Service Bulletin

Bulletin No.: PIT6132E

Subject: Hum Buzz Vibration Type Noise From HVAC When Set To Defrost Or Floor Positions

6727886

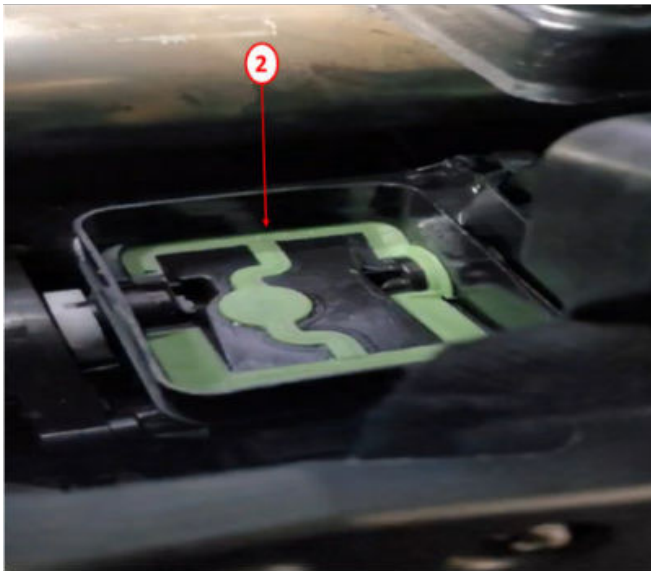
Involved Region or Country	North America
Condition	<p>Some customers may comment of a hum, buzz, or vibration type noise coming from the HVAC when the mode is set to the defrost or floor positions along with higher blower speeds and higher temperature settings. If the HVAC mode is changed to include the instrument panel dash vents the noise will be gone.</p> <p>Note: Replacing the HVAC case will not correct this condition and if the HVAC case is replaced the new case will need the repair shown below to resolve the noise.</p>
Cause	<p>The cause of this concern could be the HVAC instrument panel dash vent door seals (2) vibrating against the HVAC case, shown below. This concern only happens when the HVAC instrument panel dash vent doors (2) are in the closed position along with the HVAC set to a higher temperature and blower speed.</p>
